SUBJECT: FINAL RESPONSE TO TASK INTERFACE AGREEMENT 2015-01,  
ASSESSMENT OF THREE MILE ISLAND NUCLEAR STATION'S USE  
OF A NON-SEISMIC QUALIFIED CLEANUP PATH FOR THE  
BORATED WATER STORAGE TANK

## **TASK INTERFACE AGREEMENT 2015-01**

### **ASSESSMENT OF THREE MILE ISLAND NUCLEAR STATION'S USE OF A NON-SEISMIC**

#### **QUALIFIED CLEANUP PATH FOR THE BORATED WATER STORAGE TANK**

**Figure 1: Sketch of BWST Cleanup Flow-Path**

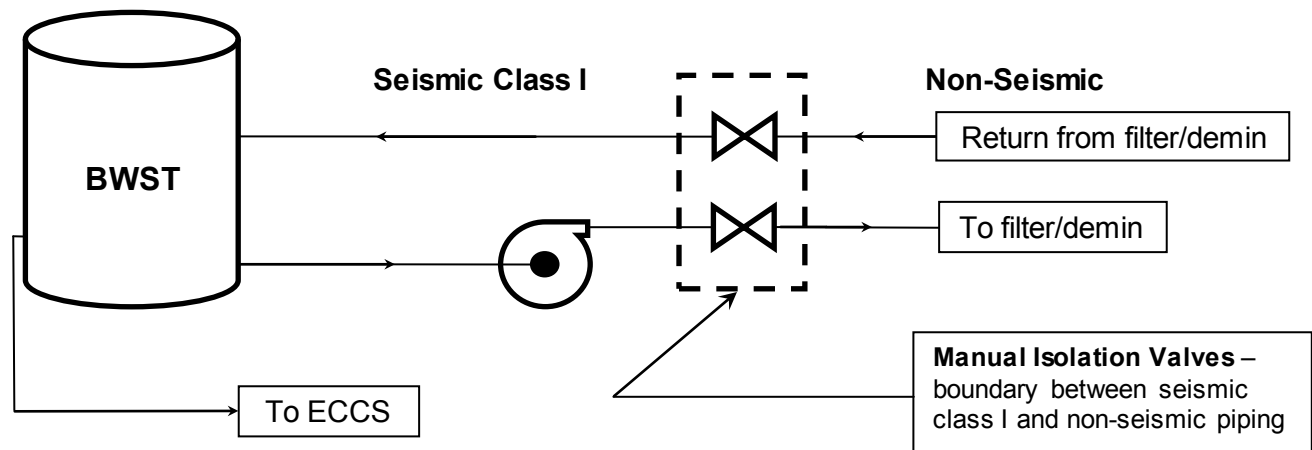
TIA assessment, the physical concern underlying the licensing basis discussion is that an earthquake could rupture the non-seismic piping when it is in communication with the BWST (i.e., boundary isolation valves are open), rendering the tank inoperable from the TS standpoint due to a reduction in the tank's inventory. This would prevent the BWST from supplying a sufficient amount of borated water to the ECCS injection pumps, which would preclude the system from being credited assuming there was a requirement for it to withstand a safe-shutdown earthquake (SSE) while maintaining operability in accordance with TS.

Based on a review of TMI's licensing basis (i.e., the draft GDC and design bases in the UFSAR), the NRR staff has concluded that the BWST cannot be credited to perform its intended safety function when it is connected to the non-seismically qualified piping for cleanup. This configuration is unanalyzed and renders the BWST inoperable according to TS. Also, manual actions are not approved as a justification for compliance with Criterion 2 of the AEC draft GDC. Finally, since this viewpoint represents a consistent position from original licensing to the present, the NRC staff position does not constitute backfitting.
